APPEAL SUMMARY

Appeal ID: 21995	Project Address: 2124-2140 NE Sandy Blvd
Hearing Date: 10/16/19	Appellant Name: John Flynn
Case No.: B-004	Appellant Phone: 5039395130
Appeal Type: Building	Plans Examiner/Inspector: Preliminary
Project Type: commercial	Stories: 2 Occupancy: B Construction Type: V-B
Building/Business Name:	Fire Sprinklers: No
Appeal Involves: Alteration of an existing structure LUR or Permit Application No.:	
Plan Submitted Option: pdf [File 1]	Proposed use: Office (B)

INTERIOR IMPROVEMENTS
SECOND FLOOR OFFICE SUITE
2124-2140 NE SANDY BLVD.
PORTLAND, OREGON 97202
OLLER FAMILY, LLC

1 2nd FLOOR PLAN
GROSS FLOOR AREA = 1,235 sf

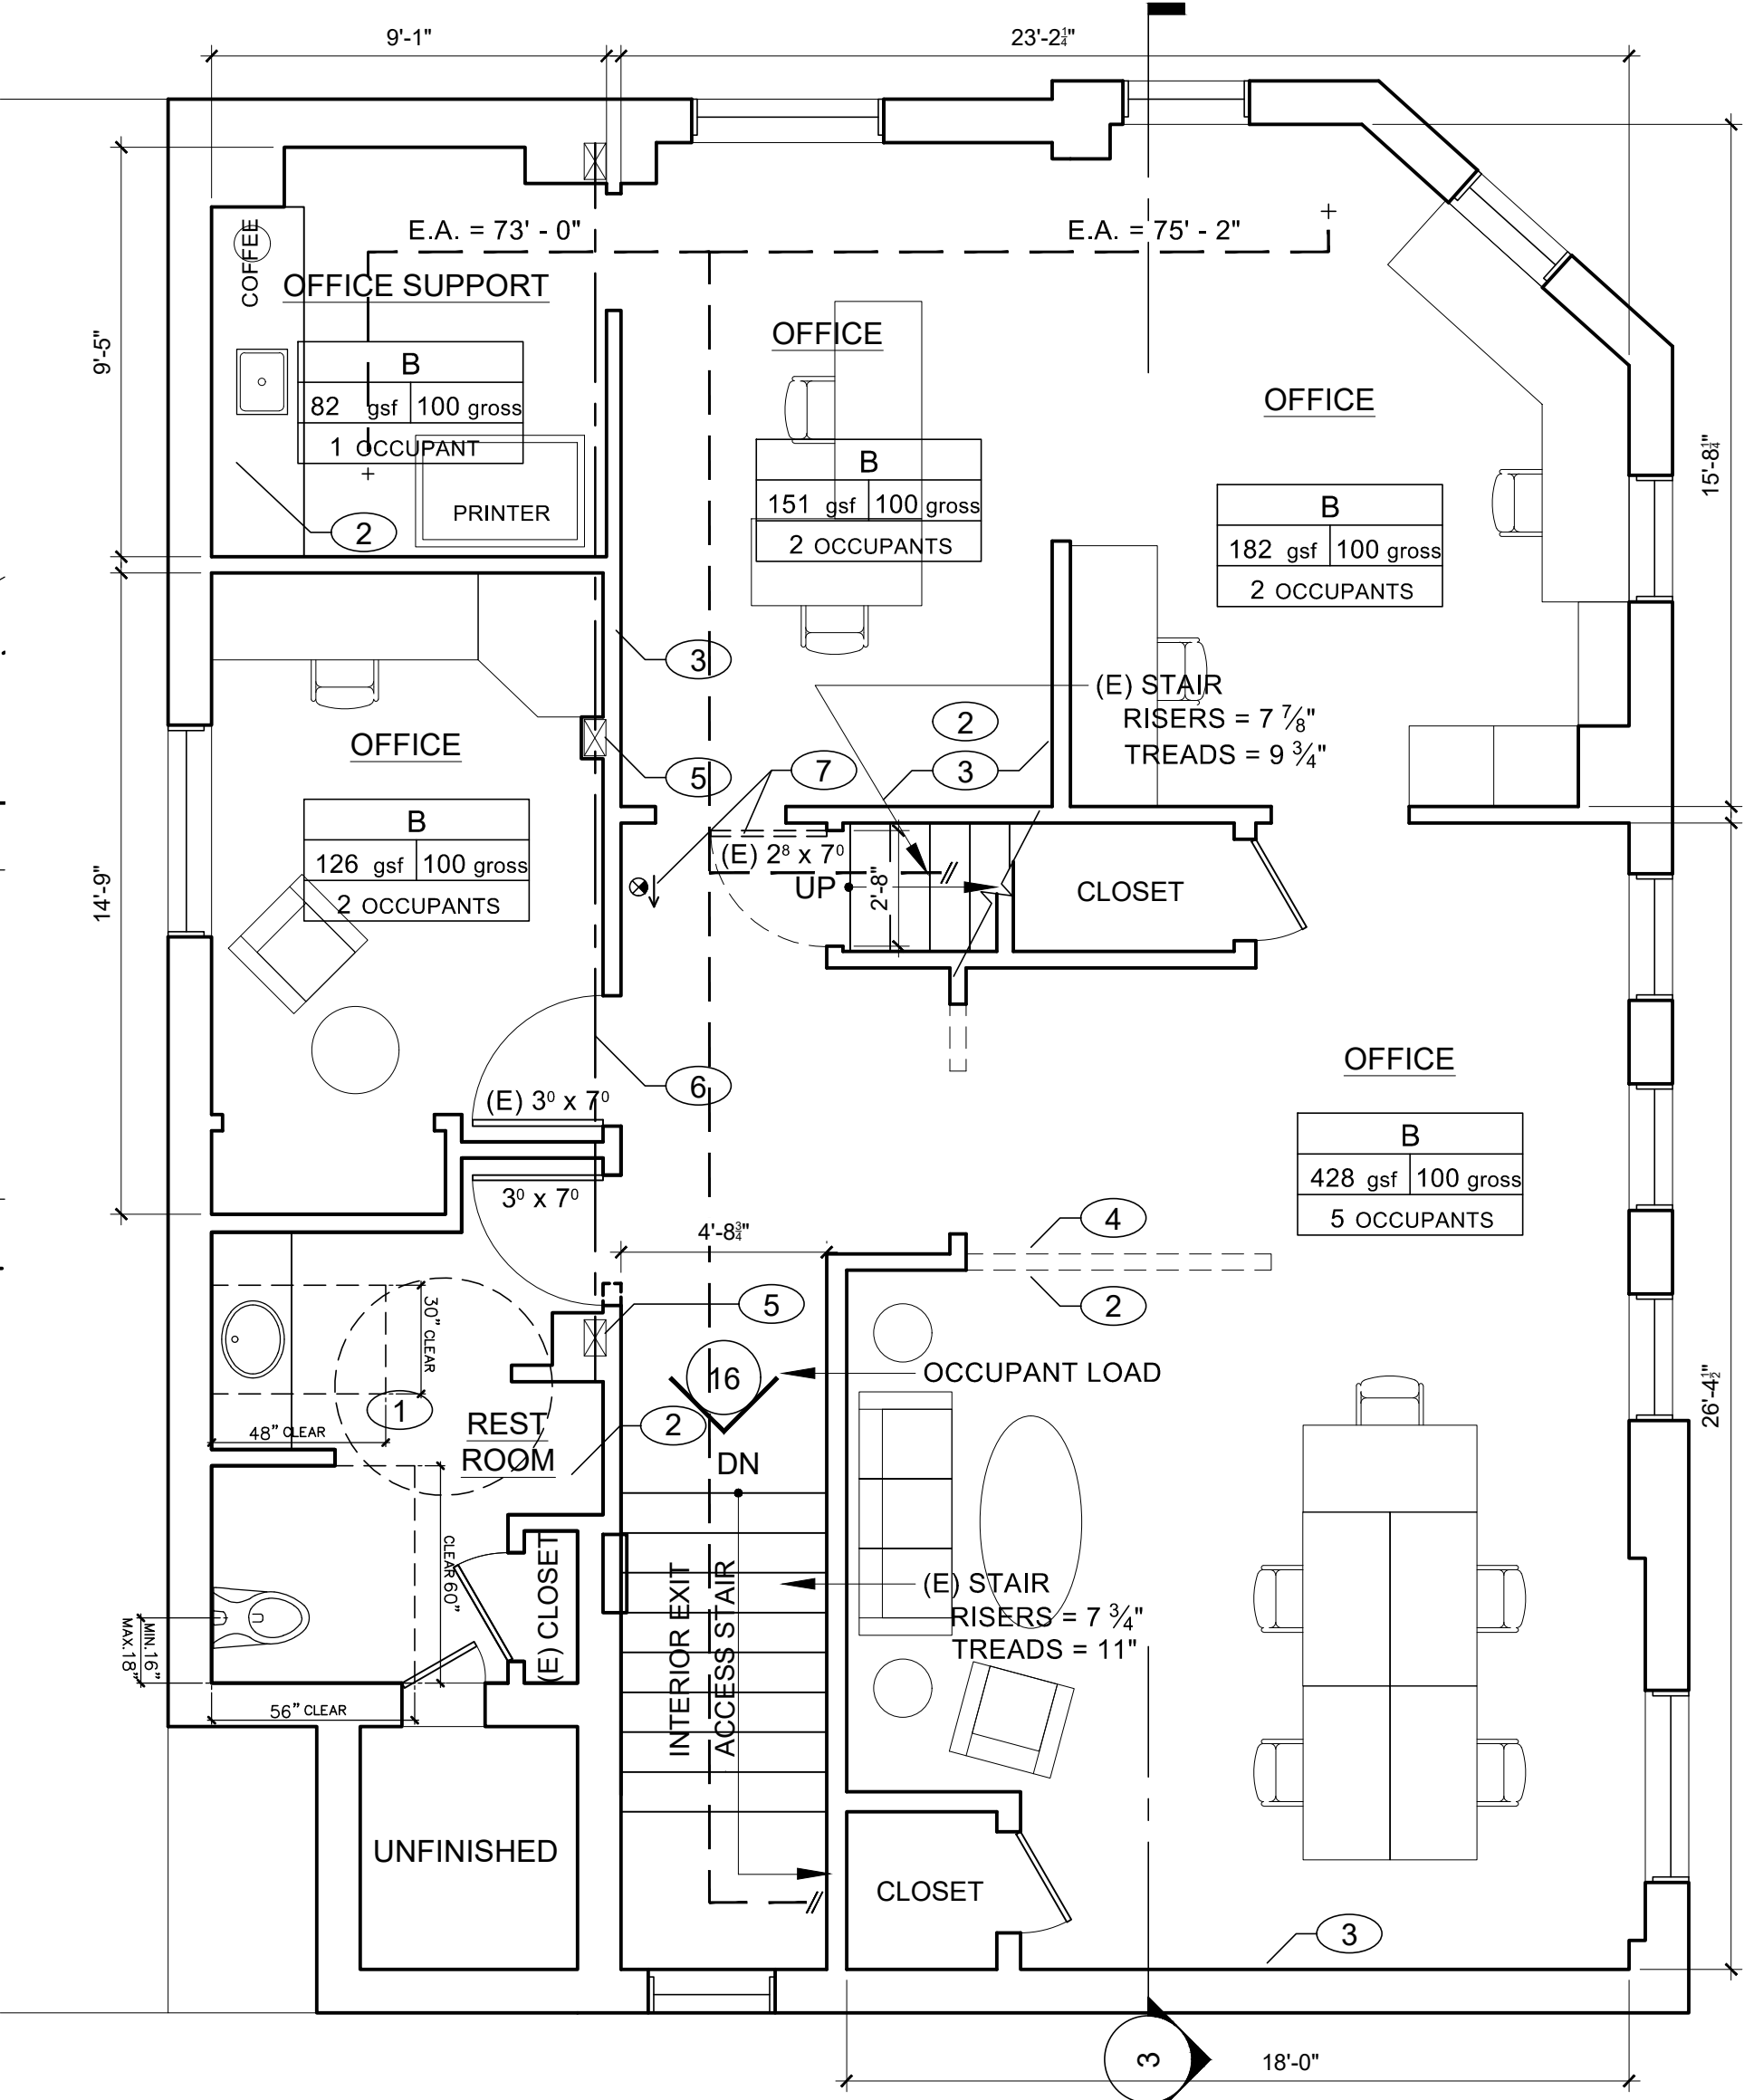
Proposed Design	This is an interior alteration to an existing second floor office space (previously permitted as an office occupancy, no change of use/occupancy). There is a finished attic space above the second floor that qualifies as a mezzanine space (see Plan 2, sheet 2.) Both spaces are not sprinklered. The total occupant load for the second floor and mezzanine is 16. Only one exit is required per OSSC Table 1015.1. The calculated exit travel distance from the mezzanine space is 82'-0" which exceeds the maximum limit of 75'-0" per OSSC Table 1021.2(2) by seven feet. (Note: the last 3 feet of the calculated 82-foot exit travel distance is beyond the point of exit discharge, but included in the overall length because the exit door occurs in a recessed alcove (see Plan 1, sheet 2.)
------------------------	--

Reason for alternative	This is an existing condition and the amount by which the exit travel distance exceeds the maximum is less than 10% (7 ft < 7.5 ft). The path of exit travel is simple and easy to navigate. The proposed design calls for removal of an existing door at the bottom of the mezzanine stairs and a lighted directional exit sign on the wall opposite the mezzanine stair bottom landing (see Keyed Note 7, Plan 1, sheet 1.)
-------------------------------	---

Single exit from 3rd floor: Hold for additional information.
